Office Action Summary

09/284,117

MEDEBACH ET AL.

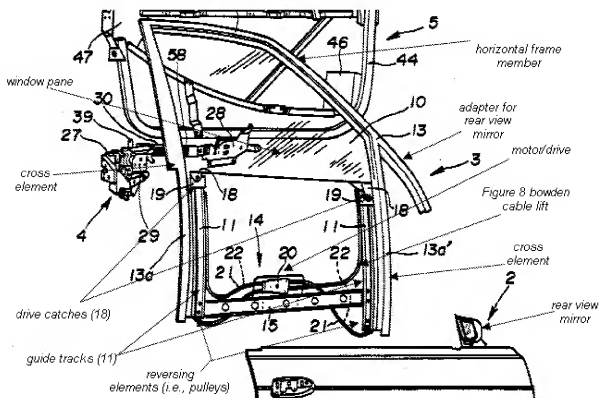
As best understood, claims 1-16 are further rejected under 35 U.S.C. 102(b) as being anticipated by Yamagata et al. (5,226,259). As shown in the Figure below, Yamagata et al. (5,226,259) discloses a frame member comprising a horizontal member, two vertical/cross members (13a and 13a'), a pair of guide tracks mounted to the vertical members (13a and 13a'), "adjustable" drive catches (18, and mounted via fastener to element 19), a Figure 8 Bowden cable connected to a motor drum (20) and

to the drive catches (18), which drives a window pane (10) vertically along the guide tracks (13a and 13a') and the frame member is inserted into a "door hollow" (5).

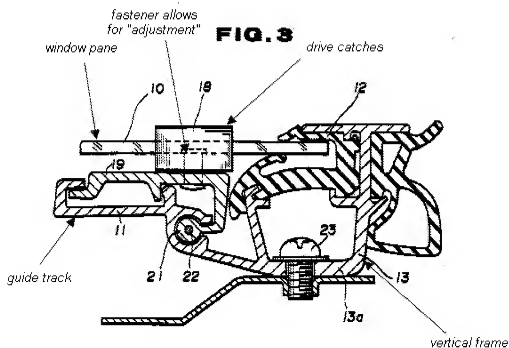
As shown below, a more detailed drawing of the guide track, drive catch, and vertical frame are depicted.
